FOI reference: 24-144

From: [Henriquez, Jose](#)
To: [GarciaBermudez, Diana](#); [TCCS_DC DevelopmentCoordination](#)
Subject: FW: Blocks 25 & 26, Section 43, 100 & 102 Macarthur Place, O'Connor ACT - Proposed Development Waste and Streetlight query TTW_239126:
Date: Wednesday, 20 December 2023 8:23:59 AM
Attachments: [twemailsignature.jpg_5698af16-5816-4e5c-8dfa-c2371491fc7b.png](#)
[C02 Concept Plans - Ground Floor.pdf](#)

Proposed Multi-Unit Housing
 Blocks 25 & 26, Section 43, 100 & 102 Macarthur Place O'CONNOR ACT

Concept Plans: Ground Floor
 Scale: As Shown @ A3

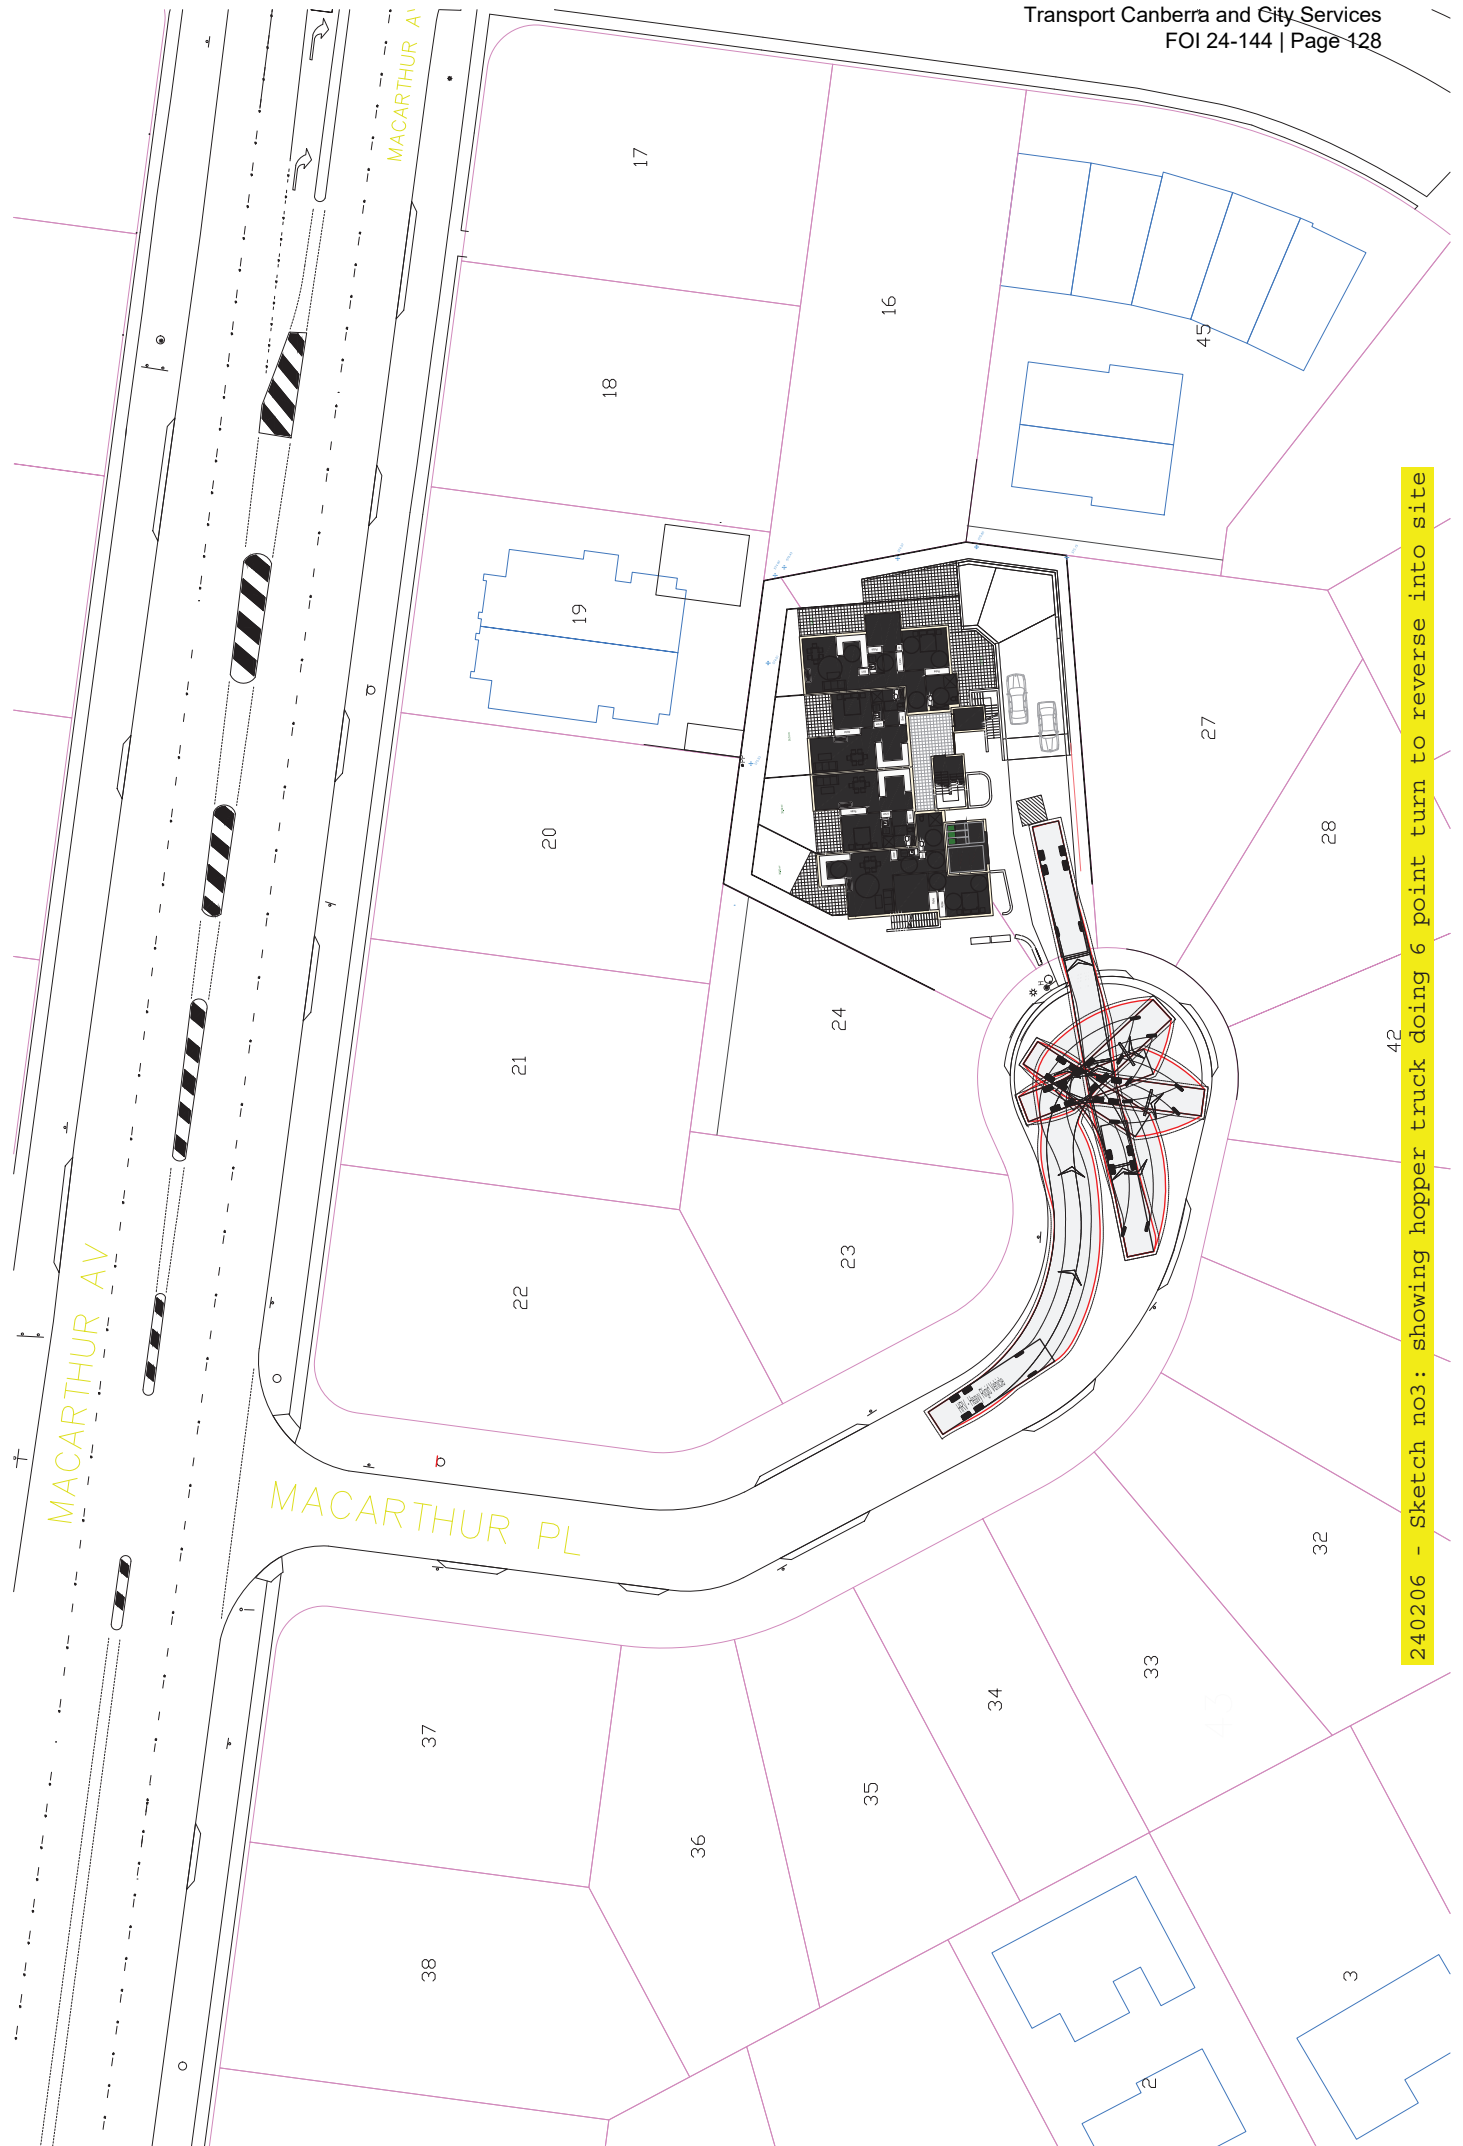
There is insufficient space on kerb as there is only 6.9m free space, with 100mm clearance to an already reduced 3m wide driveway (Clearance from DCCfWM-2019 Figure 3.2). This 6.9m also includes a streetlight obstruction. It is preferable the streetlight not be relocated, which would reduce free kerbspace by a further ~600mm

Reducing bins required to nominally 4x waste, and 4x recycling, would take up 6.6m of kerbspace, which will fit if the lightpost is removed, or relocated further back into verge outside of clashing with bin collection, or relocated to a neighbours verge.
If an additional bin was removed, then the lightpost could remain.

Can you please advise on possibility of relocating lightpost.
And on performance solution of reduced bins.
